Service Bulletin No. 331B

MODEL D4500 / D4505 Series Coaches	TYPE Field Change Program	SECTION/GROUP 12--Suspension	DATE Sept. 11, 2009
SUBJECT TAG AXLE TIE ROD LOCK CLAMPS REPLACEMENT			
CONDITIONS

Ref. NHTSA Recall No.: 09V-350

Figure 2.

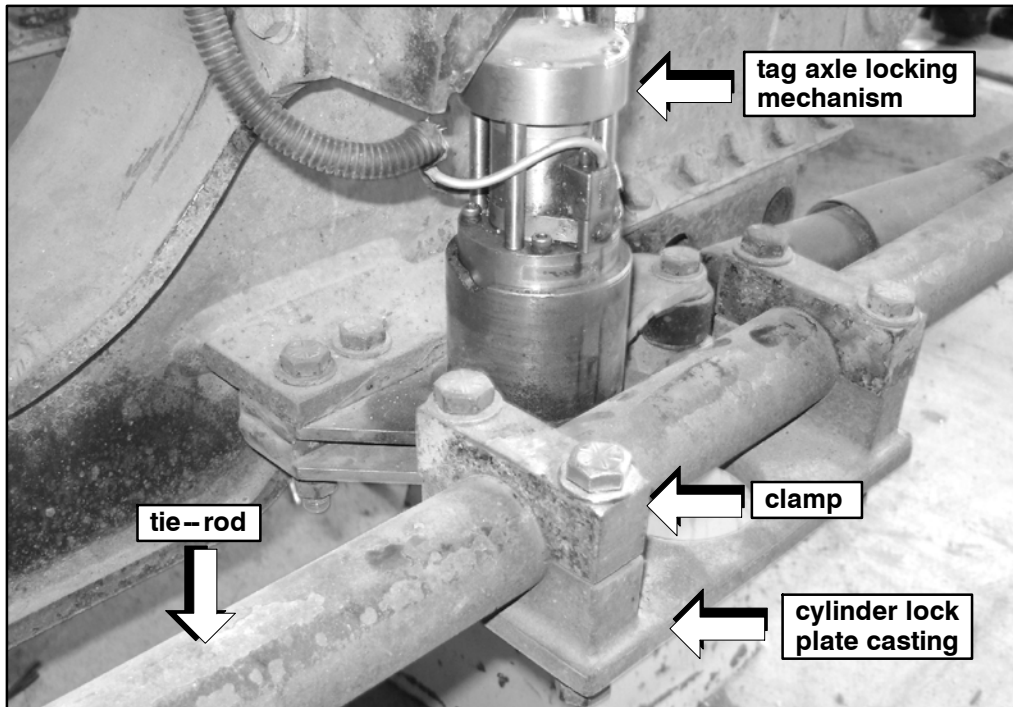
5. Locate the tag axle locking mechanism (refer to Figure 2).

6. Using a clean cloth, remove any dirt or grease from the tie rod and clamps (refer to Figure 2).
Visually inspect the tie rod for scuff or drag marks indicating that the tie rod has moved within the lock clamps.

Upon inspection, if scuff or drag marks are present indicating tie rod movement within the lock clamps, loosen the clamp hardware and re-orientate the tie rod / clamp relationship by aligning the beginning of the scuff marks on the tie rod with the edge of the applicable clamp.

Figure 3.

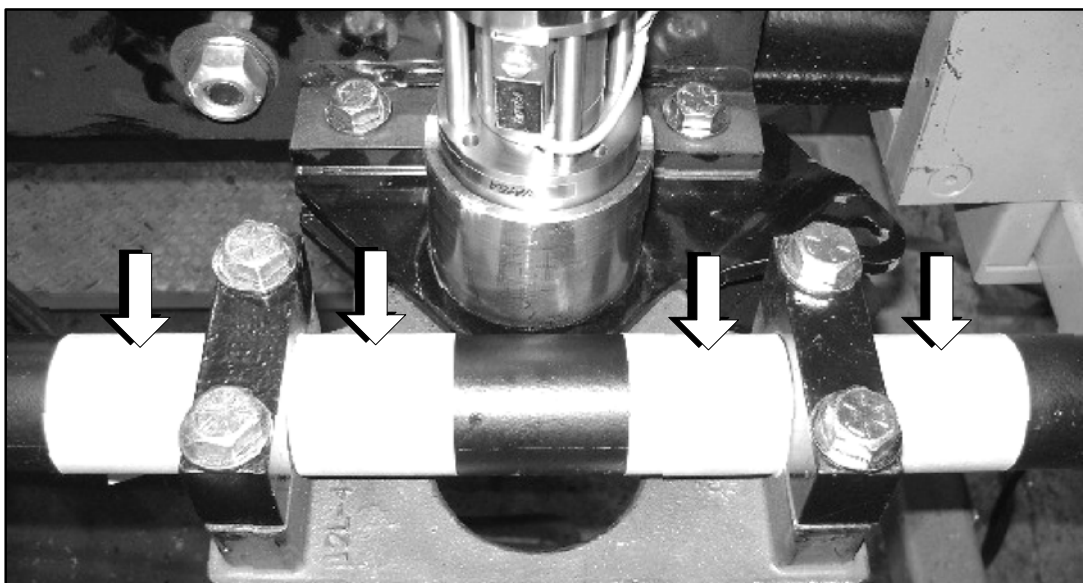
7. Using masking tape, mark each side of each clamp to indicate the tie rod / clamp relationship for re-installation at a later step in this procedure (refer to Figure 3).

Figure 6.

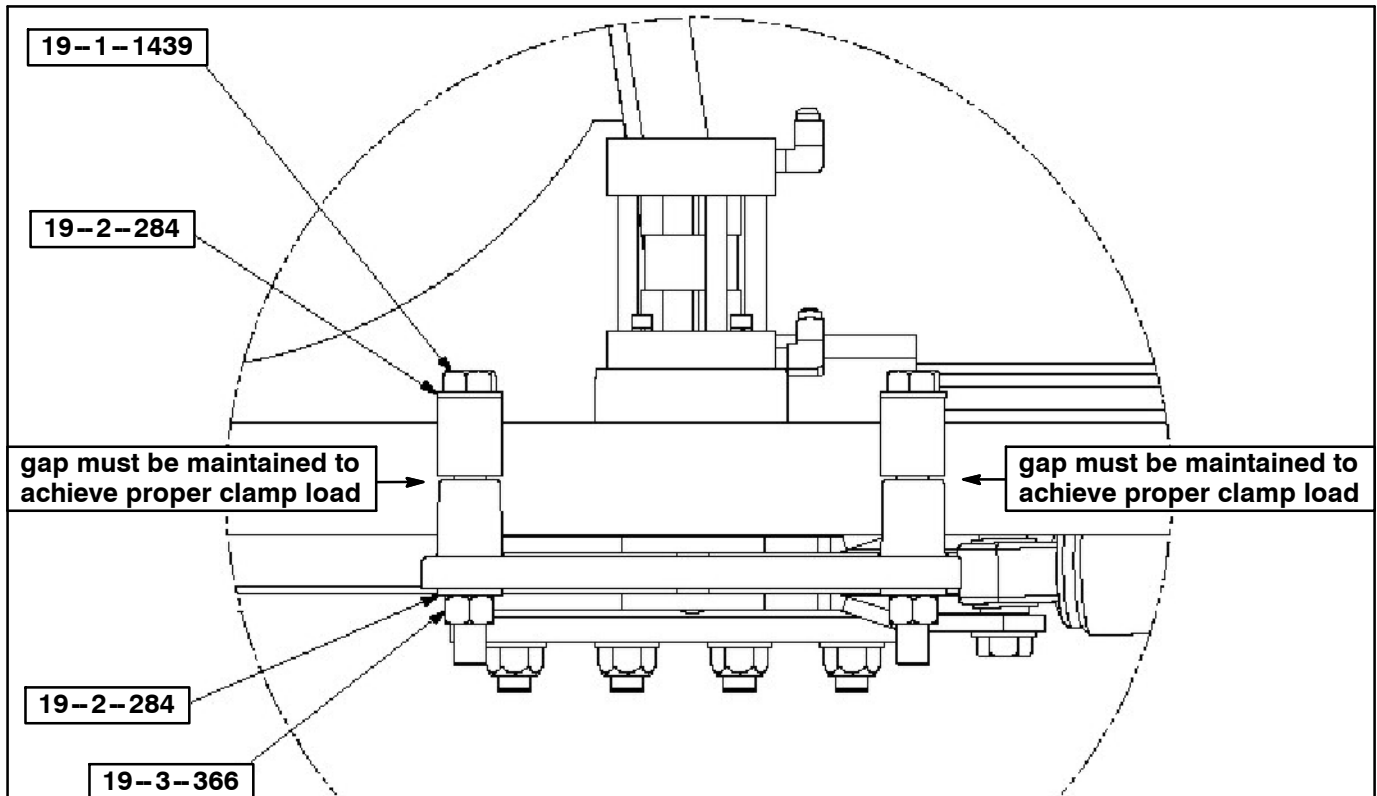
11. Re-assemble lock casting into the lock cylinder plate (refer to Step 9.).
12. Apply loctite, p/n 21-7512-5, to the threads of the capscrews, p/n 19-1-1439.
13. Using the new hardware provided, align and install new clamps, p/n 12-04-1153, in between the masking on the tie rod (refer to Figures 3 and 6).
14. Line up the lock plate with the lock cylinder. Snug up all bolts to secure the clamps in position.
15. Turn coach ignition to the OFF position, locking the cylinder into the plate.

To achieve proper clamp load, the gap must be maintained between the upper and lower clamps (refer to Figure 6).

16. Torque the lock cylinder plate capscrews to 85–90 lbs.-ft. Torque nut, p/n 19-3-366, to 70–80 lbs.-ft.
